**PLANNING COMMISSION
MEETING AGENDA
REGULAR MEETING**

5. PRELIMINARY SITE PLAN APPROVAL – (SP JPLN2025-0001) – Proposed GFA Forsyth Site Condominium, 9 single family detached units, North of Wattles, West of Dequindre (4189 and 4197 Forsyth; PIN 88-20-13-401-028, -037 & -038), Section 13, Presently zoned R-1C One Family Residential Zoning District.

Preliminary Site Condominium Review For City of Troy, Michigan

Project Name:	GFA- Forsyth
Applicant:	Gary Abitheira
Plan Date:	April 30, 2025
Location:	4165, 4189, & 4197 Forsyth Drive
Zoning:	R-1C, One-Family Residential District
Action Requested:	Preliminary Site Plan Review

NOT FOR CONSTRUCTION **P-1**

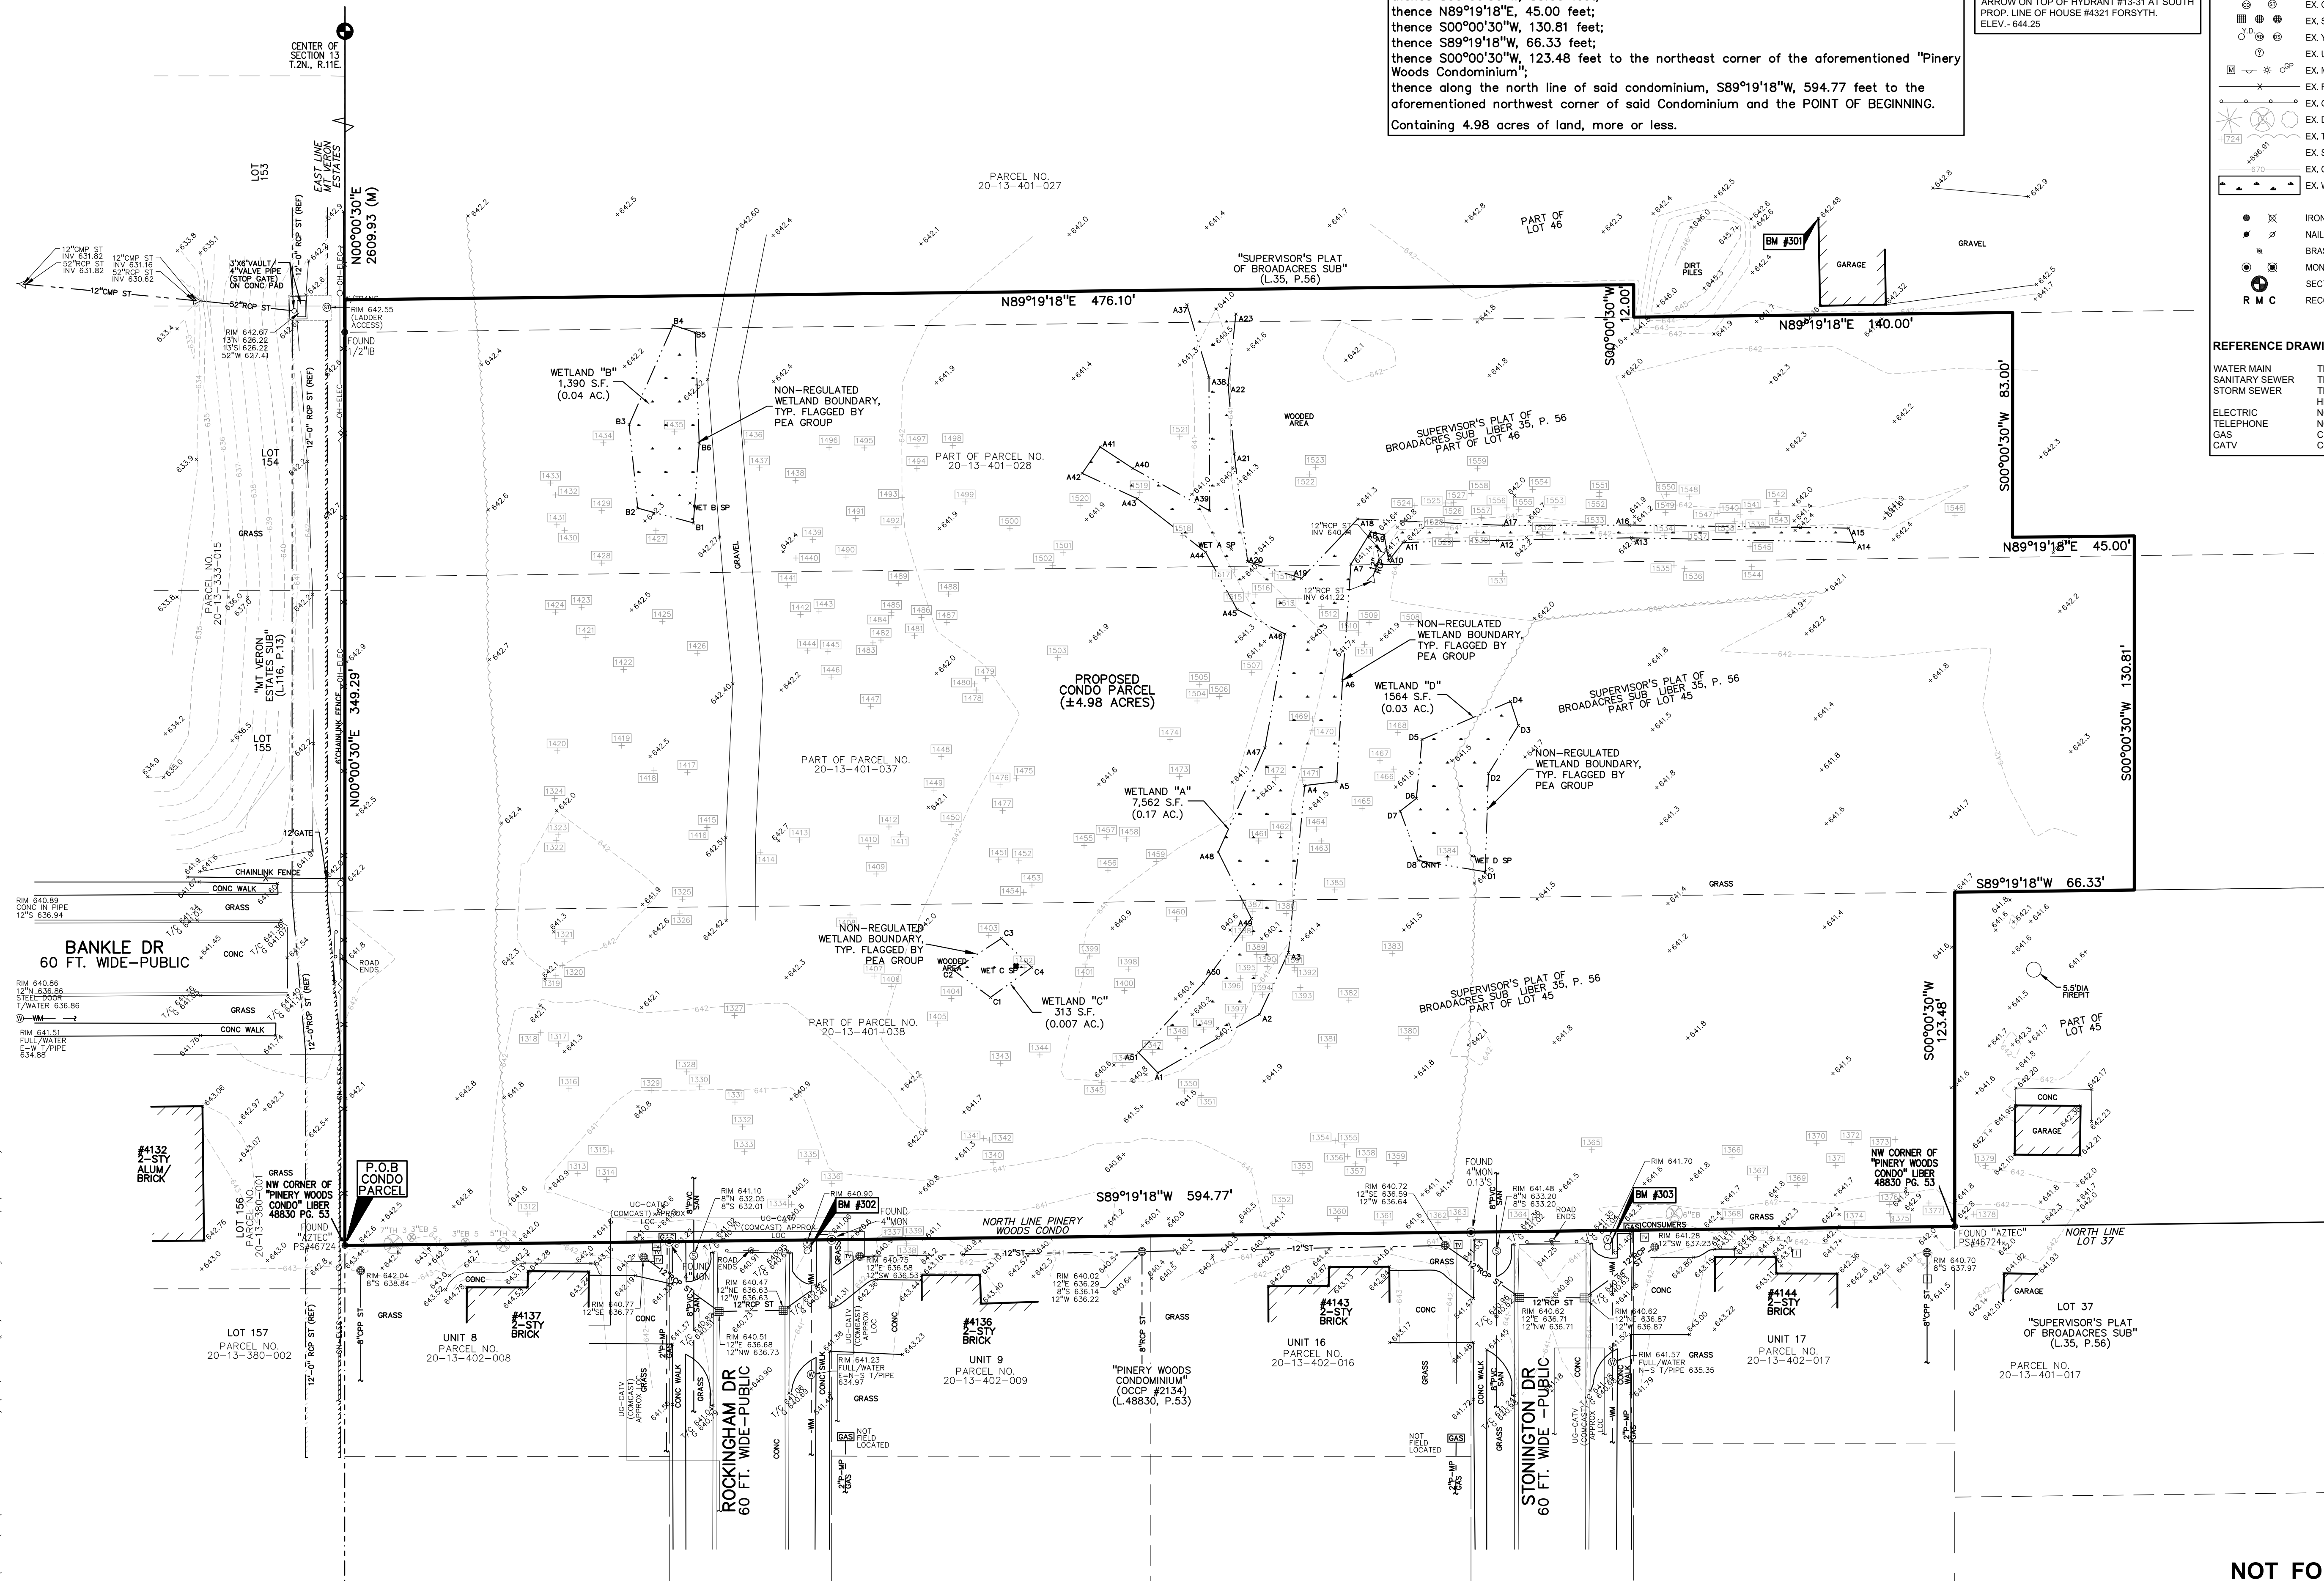
Topography: A topographic survey has been provided on Sheet P-1. The site is relatively flat with minor elevation changes. In a report dated November 1, 2024, PEA Group states that the site is predominantly flat with shallow depressions.

PEA JOB NO.	2018-028
P.M.	JBT
DN.	KMB
DES.	DSK
DRAWING NUMBER:	T-1.0

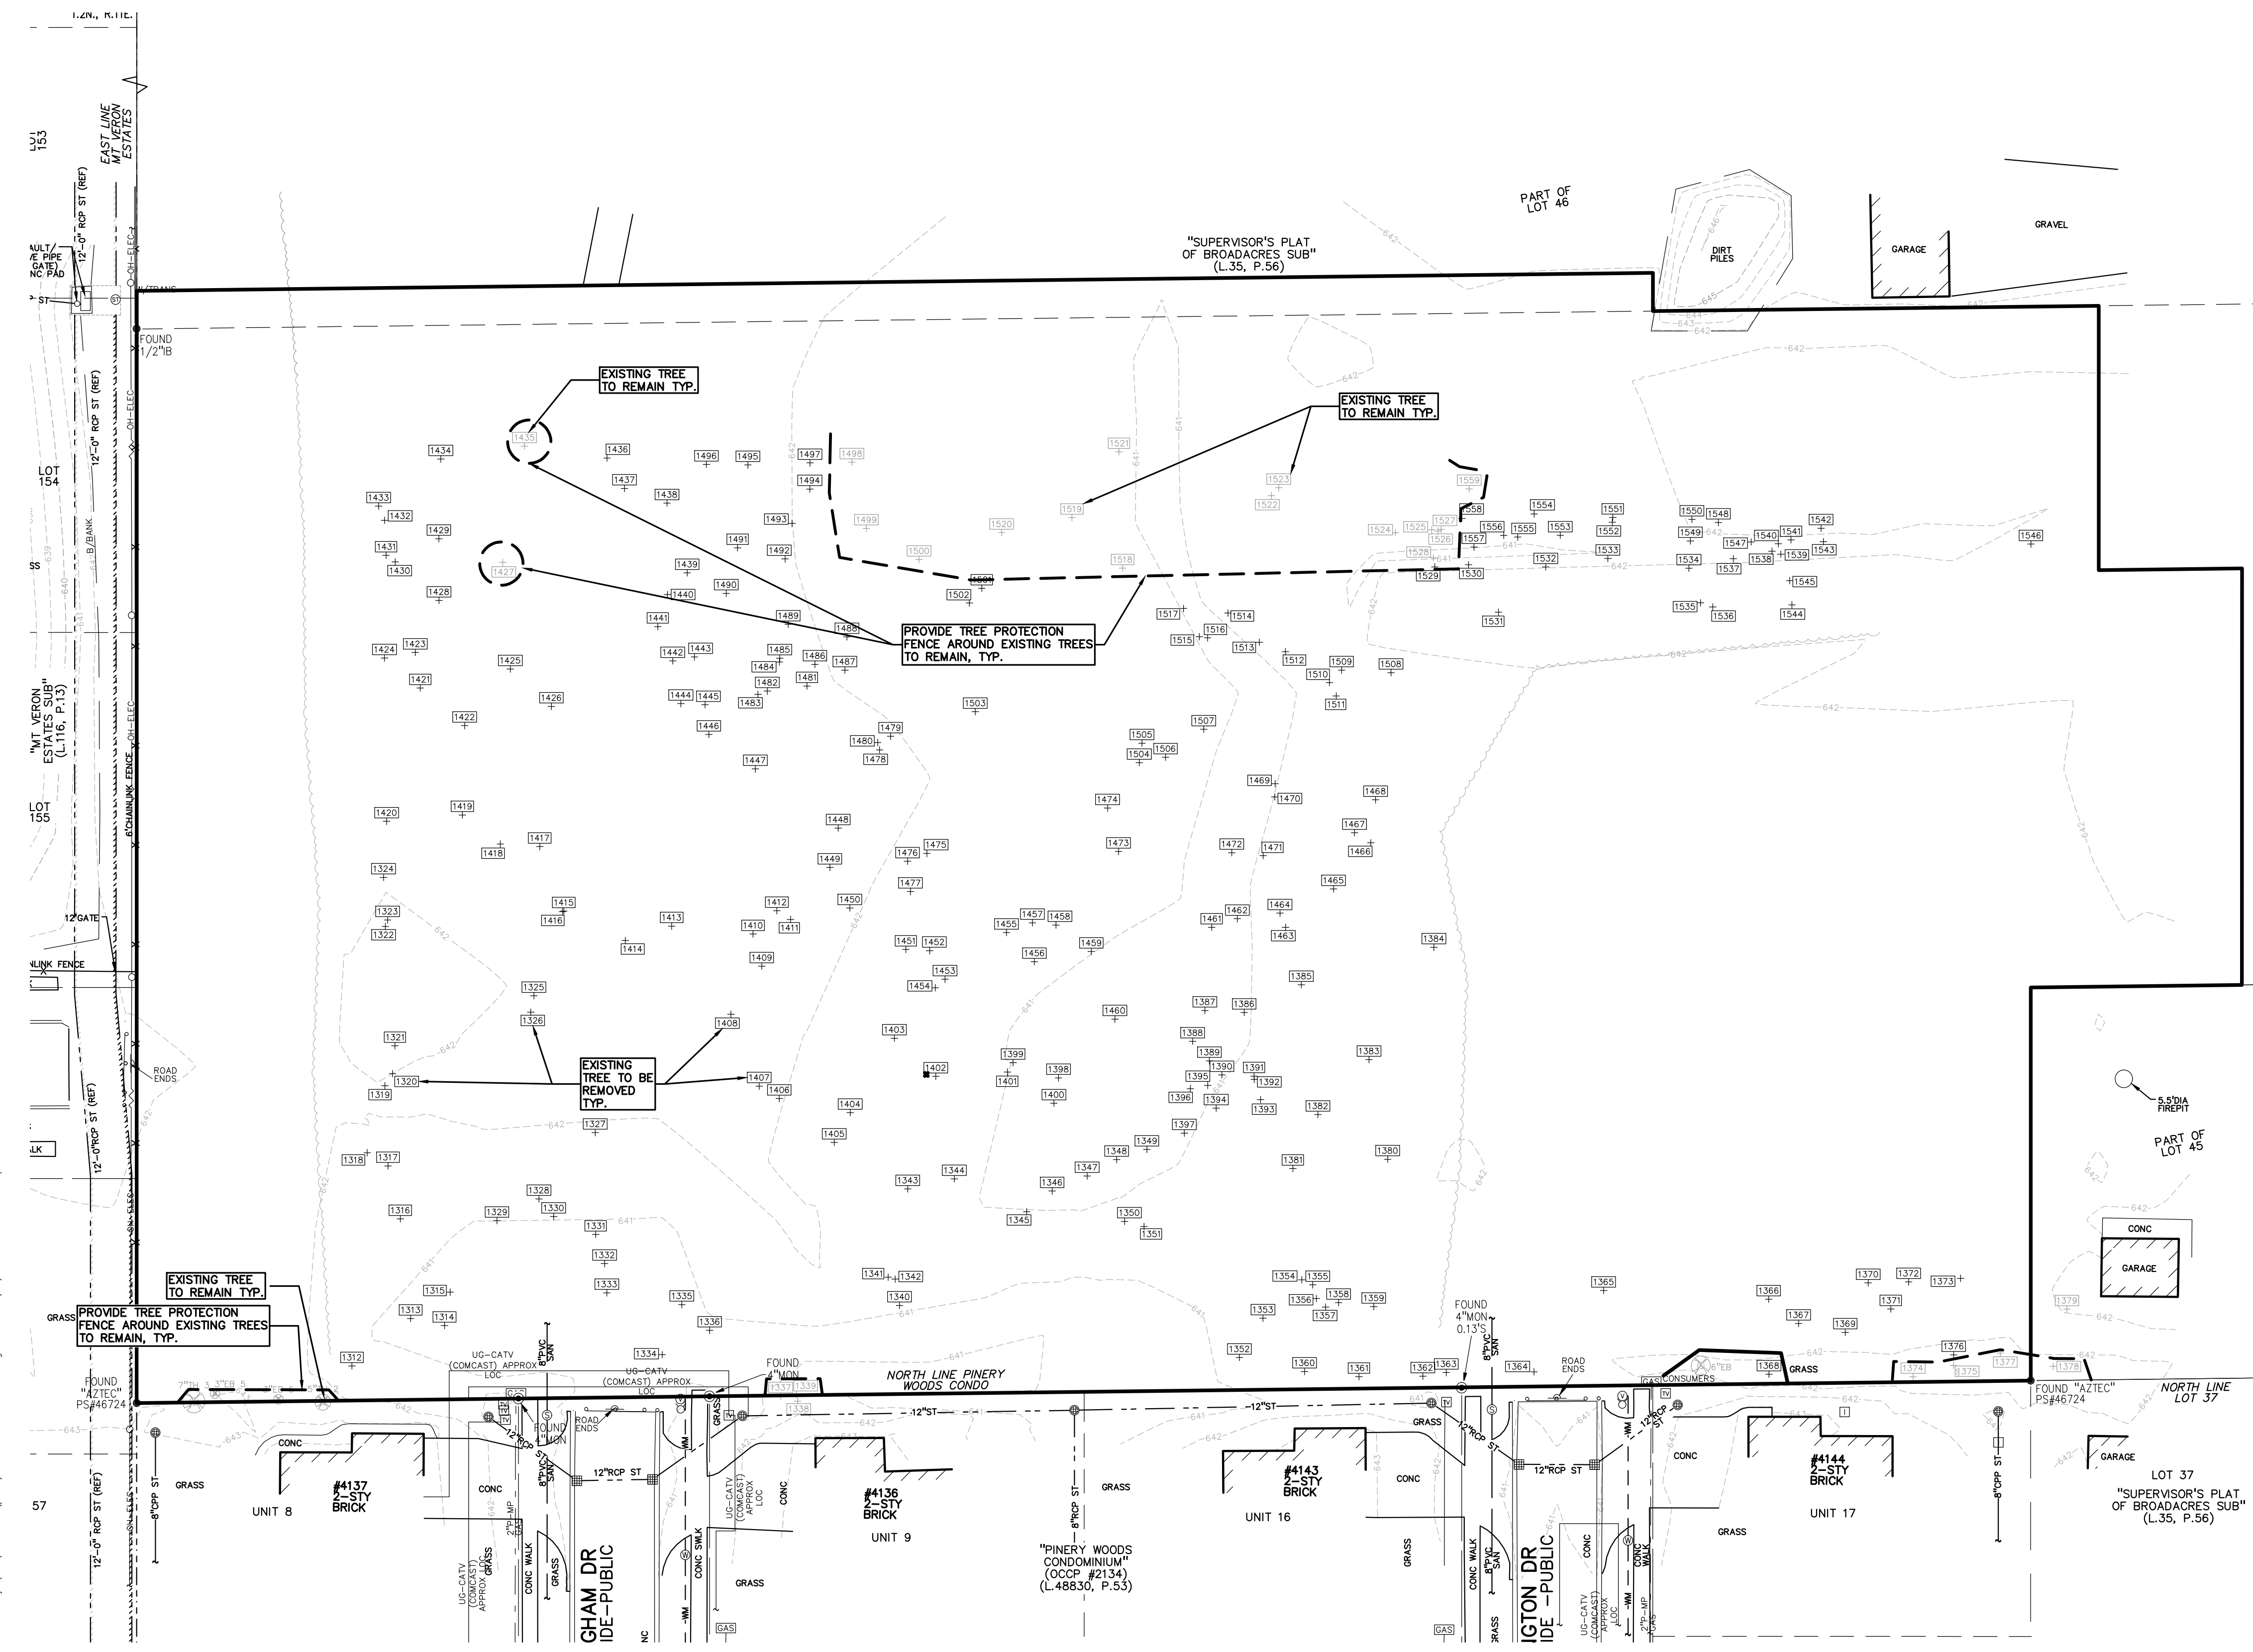
Woodlands: Most of the site is undeveloped and encumbered with tree cover. The tree inventory provided identifies 248 existing trees on site. A tree replacement plan is provided on Sheet T-1.0, with details outlined in the table below.
